COMPILED COMMENTS RECEIVED ON THE PRELIMINARY DRAFT -

PART 0 'INTEGRATED APPROACH PREREQUISITE FOR APPLYING PROVISIONS OF THE CODE' – Doc: CED 46(27027)P

**COMPILED COMMENTS RECEIVED ON THE PRELIMINARY DRAFT -
NATIONAL BUILDING CODE OF INDIA PART 2 ADMINISTRATION - DOC: CED 46 (26990) P**

PART 3 DEVELOPMENT CONTROL RULES AND GENERAL BUILDING REQUIREMENT- DOC: CED 46 (26991) P

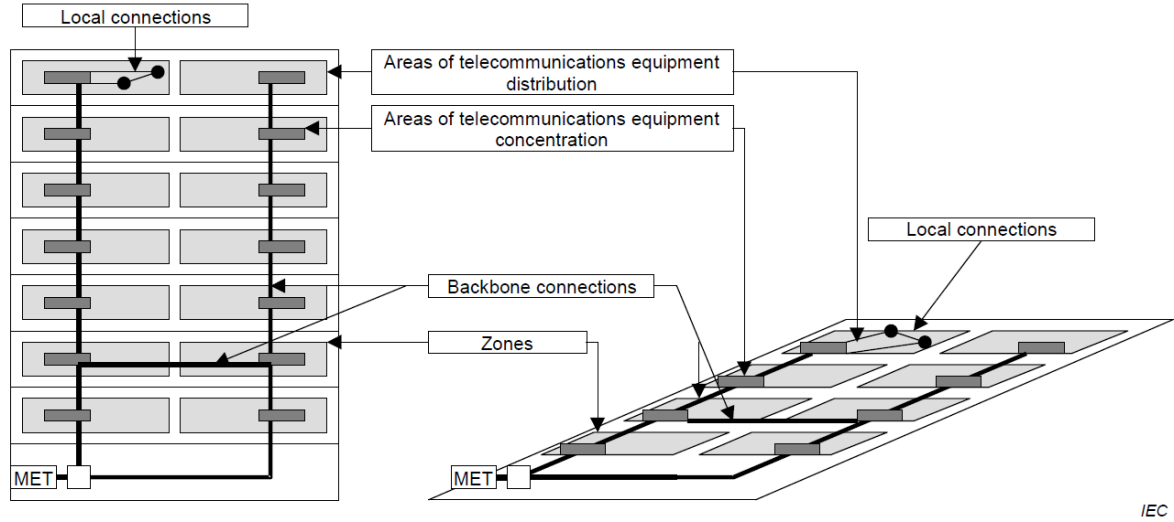
CAPE comments:

Figure 2 – Schematic of telecommunications equipment distribution and associated bonding connections

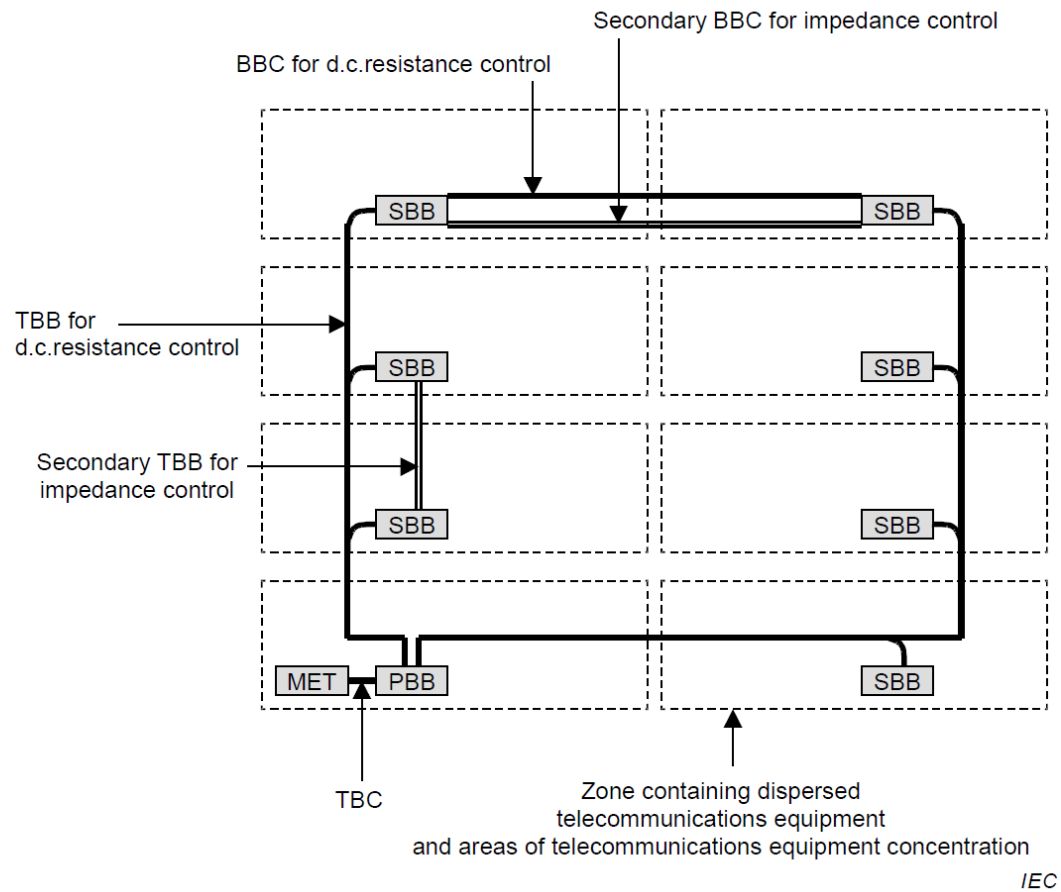
4 SPECIFIC REQUIREMENTS FOR TELECOM INFRASTRUCTURE CABLING

4.1 Telecommunications Bonding

Figure X MESH-BN with equipment cabinets, frames, racks, CBN and global earthing bonded together.

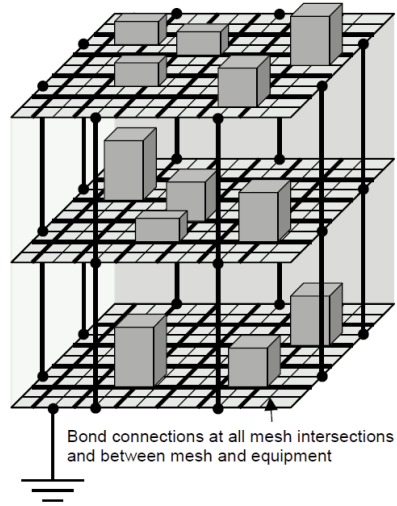
4.2 Meshed Bonded networks

The default topology as most ICT equipment has intra/inter intentional and unintentional metallic interconnections. A MESH-BN augments the protective bonding network by increasing the local density of conductors and functions by attempting to diversify and limit the radio frequency capture-loop area of the current paths such that the current density on any conductor or conductive loop is reduced to an acceptable level. The MESH-BN is a recommended practice since it simplifies installation procedures, most ICT equipment is powered by a.c. branch circuits, and most ITE employed for a computer room is suitable for placement directly into the protective earthing network. However, under certain circumstances such as a manufacturer's requirement or access provider recommendations, the ICT equipment may also be arranged into certain segregated "functional system blocks" of either MESH-BN, MESH-IBN or other form of bonding network within the same room. Figure 8 shows a simple illustration of a mesh BN and figure 9 shows a detailed illustration of Mesh BN. A merged MESH-BN and protective earthing network in buildings shall include the interconnections to the following installations,

- a) "integrated lightning protection system" according to IEC 62305-4,
- b) bonding measures of antenna installations (including satellite receiving equipment under private property) and cable networks according to series IEC 60728,
- c) bonding measures of information technology cabling according to ISO/IEC 14763-2,
- d) bonding in hazardous areas, e.g. according to IEC 60079-14.
